AD/TURBO/1

**Roto-Master (Rajay Industries, Inc.)
Turbochargers - Inspection and Replacement**

3/83

Figure 1.

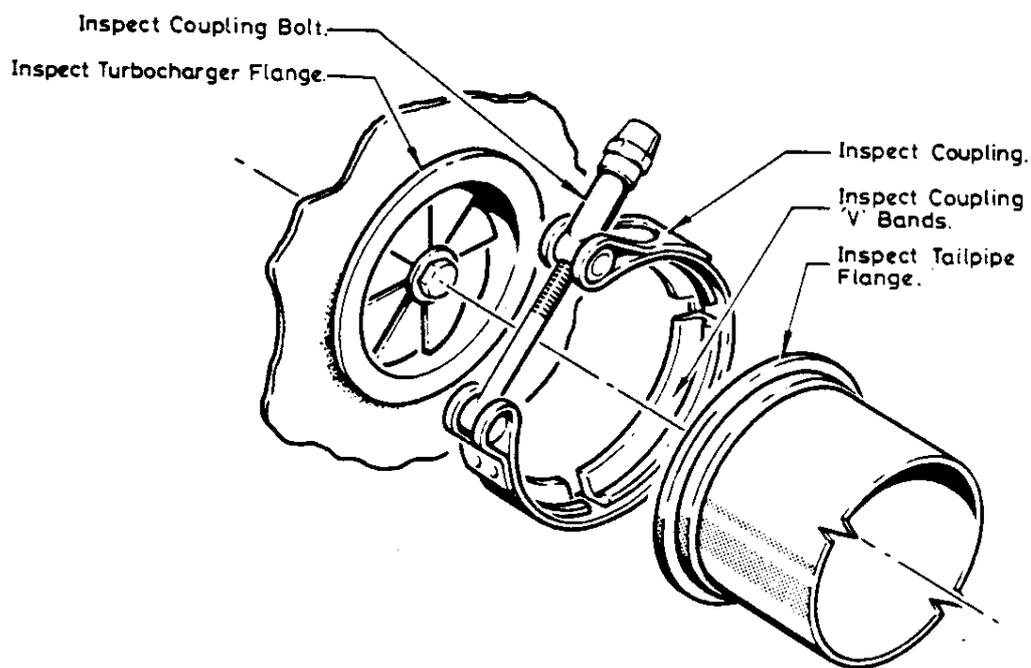
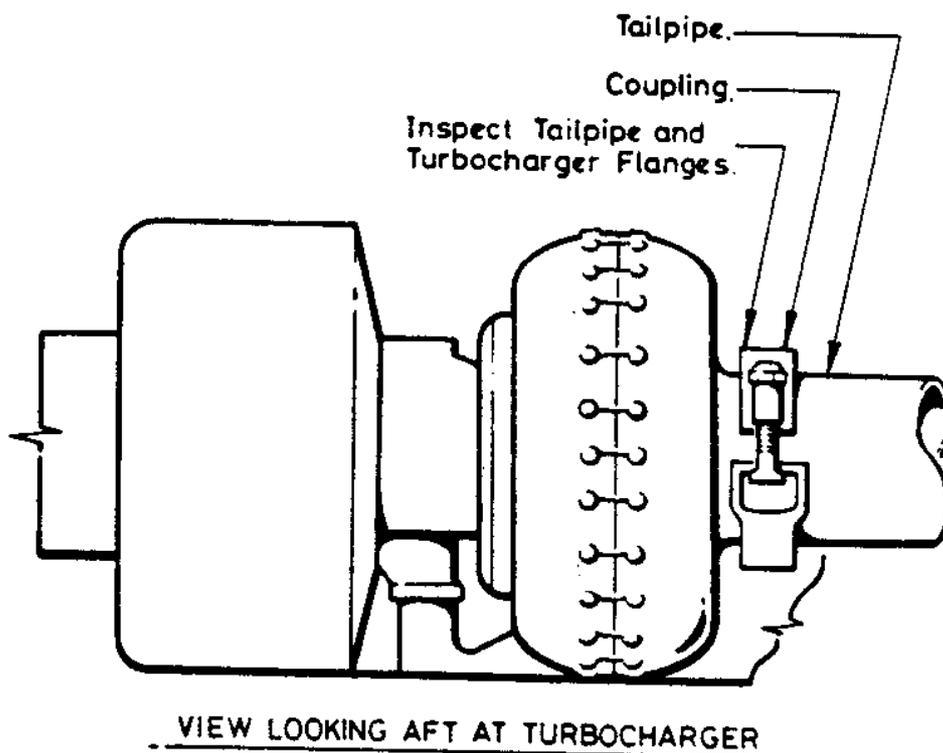
- (a) Remove the turbocharger turbine housing exhaust coupling V-Band and tailpipes (see Figure 1).
- (b) Visually inspect the turbocharger turbine housing for cracks using a dye penetrant inspection method.

- (c) Inspect coupling V-Band clamp for cracks by spreading the band segments and checking for failed spot welds and for indication of exhaust flanges bottoming in coupling V-Band (see Figure 1) and clamp bolt for bending, overstress, thread damage, and cracks (see Figure 1).
- (d) Inspect turbochargers and tailpipe flanges for cracks and distortion (see Figure 1). Remove all carbon deposits from mating flanges before reassembly.
- (e) Inspect mating area of turbocharger exhaust flange to exhaust tailpipe connection for proper mating of surfaces.

Figure 2. - TURBINE HOUSING - INTERNAL CRACKS.

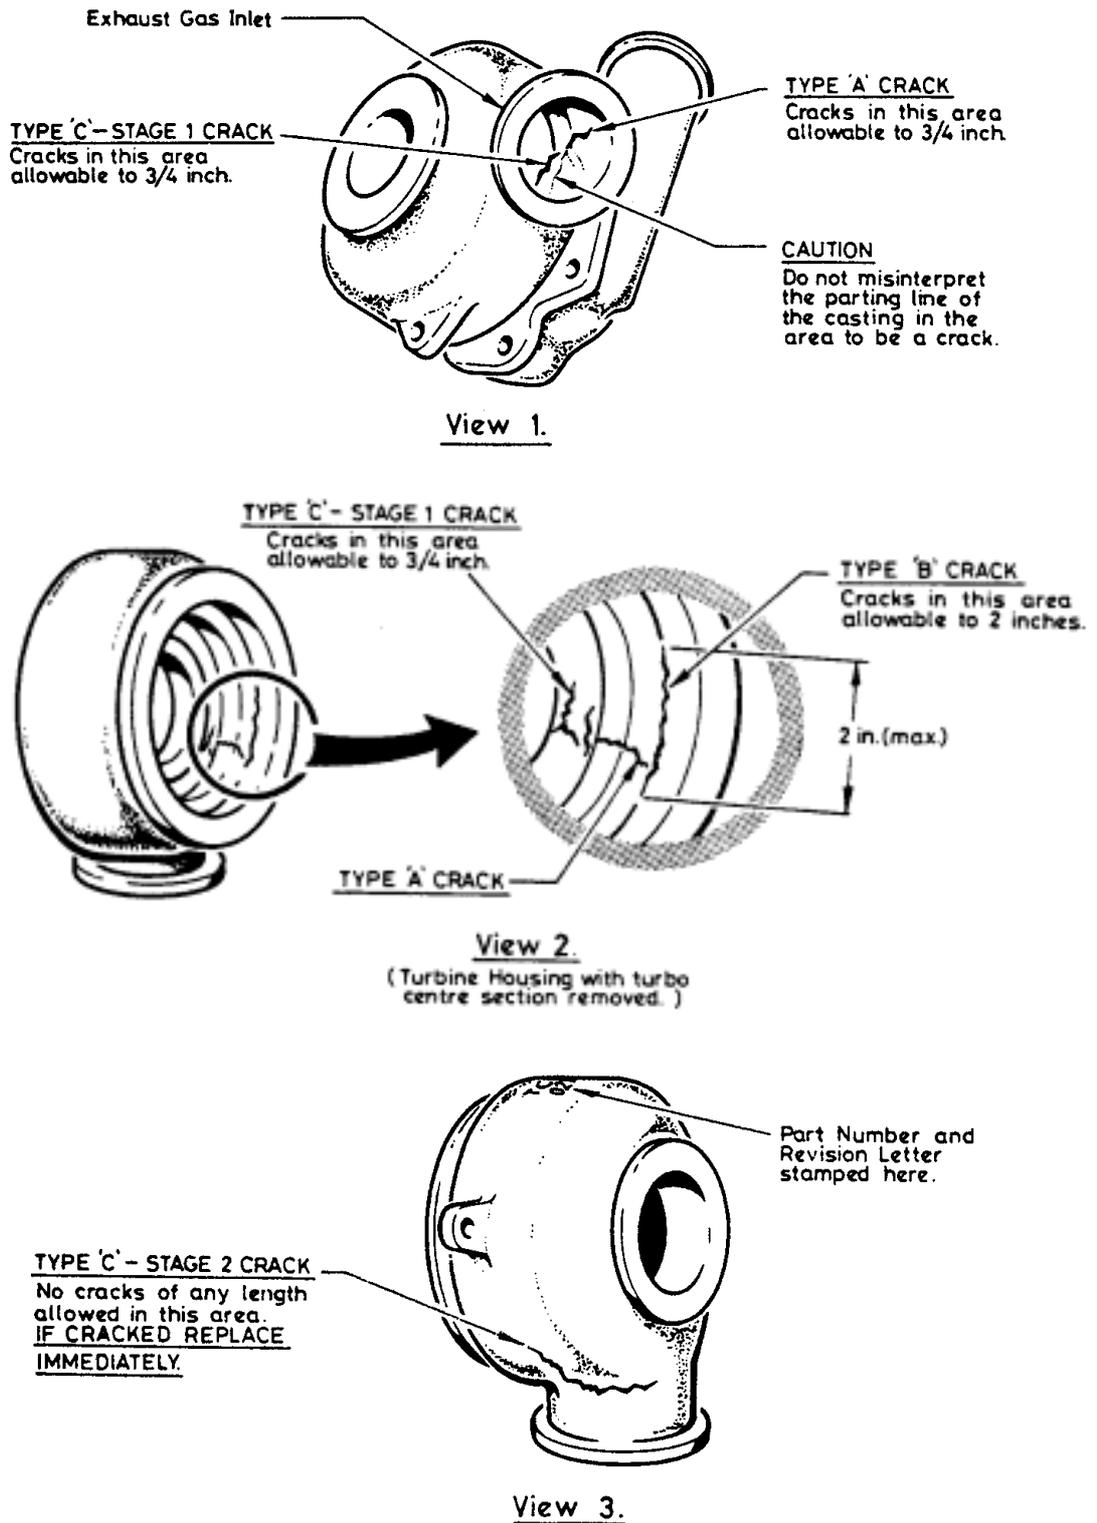
Note: The suspect area can be viewed through the exhaust port to ascertain possible presence of cracks penetrating through the outer wall as shown in Figure 2.

- (f) Inspect engine mount for indication of overheating, warpage, and corrosion, or rust. Repair as required.
- (g) If during inspection required by paragraph (b), an internal crack is found that either exceeds the limit shown in Figure 2, View 1 or 2, or a crack penetrates the outer wall of a turbine housing as shown in Figure 2, View 3, the existing turbine housing must be removed from service and replaced with a serviceable turbine housing prior to the next flight.
- (h) If during the inspections required by paragraphs (c) through (f), cracked, distorted, or otherwise damaged parts, components, or assemblies are found, before further flight repair or replace with serviceable parts, components and assemblies of the same part number.
